OPDC POST SUBMISSION MODIFIED DRAFT LOCAL PLAN

Agenda 2 for Modifications Hearings: Conformity with London Plan policy D9 on Tall Buildings 2pm Tuesday 11th January 2022

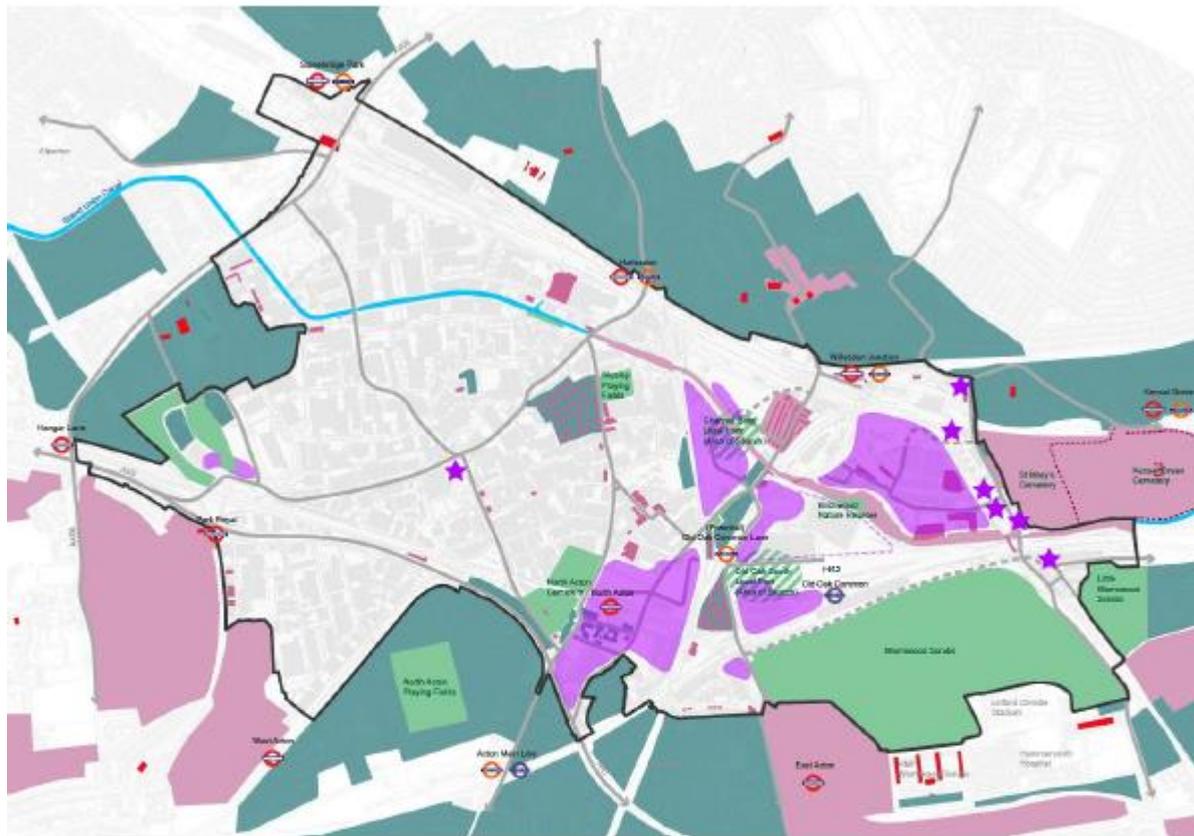
OPDC would seem to be assuming that the modified figure 3.15 is sufficient to achieve general conformity with the '*suitable location*' requirement in London Plan Policy D9.

This map of the OPDC area identifies (with asterisks) a series of specific locations for tall buildings along Scrubs Lane. All but one of these asterisks show sites on which OPDC has since 2015 granted planning consent to such buildings (in the 20- 30 storey range). As we have argued in the past, this has been an exercise of retro-fitting a Local Plan around sites acquired by speculative developers in advance of plan preparation. Nevertheless we accept that these locations are identified with sufficient specificity to meet London Plan D9.

In relation to other areas where tall and very tall buildings are planned by OPDC, this map at 3.15 defines sizable areas of several hectares in each case. The purple areas of North Acton/Acton Wells is an area of 32.9 hectares¹. Channel Gate/Atlas Road is approximately 14 hectares.

The term ‘location’ in plain English means ‘a particular place or position’. It does not mean a substantial area of many hectares or a ‘Place’ as used by OPDC in its Local Plan. The whole intent of the SoS Direction of December 2020 was that the public should be made aware, through Local Plans, of specific locations considered suitable for tall buildings. Part C of London Plan D9 sets out criteria in assessing what makes a location ‘suitable’. For London, where tall buildings have been a growing public concern, local plans are now expected to have been through a full process of consultation leading up to the identification of such locations as being ‘suitable’.

We do not see SP9 and its associated map as being even close to meeting the requirements of London Plan D9. As one of the first new Local Plans to be adopted post the Secretary of State's intervention on the Tall Buildings policy in the London Plan², we see the outcome of this examination to be critical to future interpretations of the 'general conformity' requirement on this important planning issue for all Londoners. (Nor do we see Places P5 and P7 (as referred to above) being the most significant Places where much clearer policy content is needed than in the present PSMDLP. Renumbering may be needed?).
